**Review of Noise Issues with the
Expansion of Champions Quarry
Preferred Project
1586 Wyrallah Road
Tuckurimba NSW 2480**

Prepared by
Garry Hall
1st March 2012

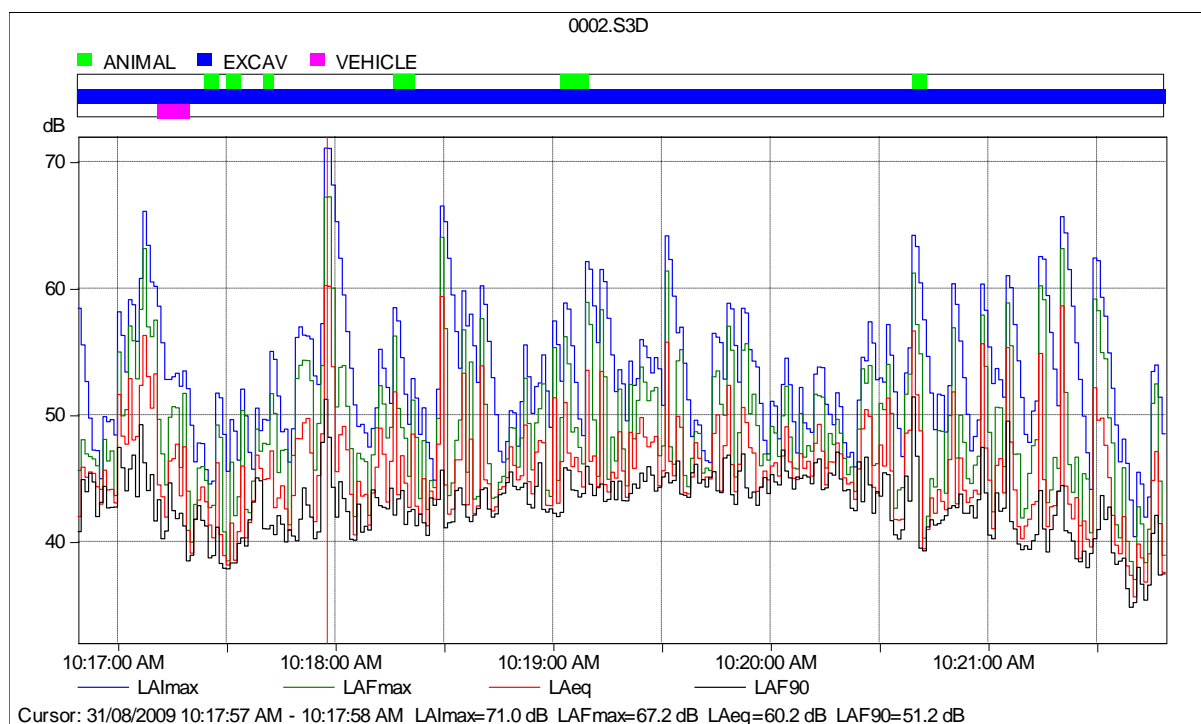
The logged profile is presented below. The coloured bands at the top of the graph indicate the duration of the marked acoustic events.

The banging of the bucket are the peaks above 60 decibels. It was noted that the difference between the L_{AImax} and the L_{AFMax} was 3.8 decibels. This is consistent with measurements I have conducted of excavators. This is considered an impulsive noise characteristic and a modifying factor of 3.8 decibels would be added to the L_{Aeq} of the excavator. The noise level of the excavator would then be assessed at 51.8 decibels if it operated for 15 minutes. This level is approximately 15 decibels above the ERM noise goal of 37 dBA at this location.
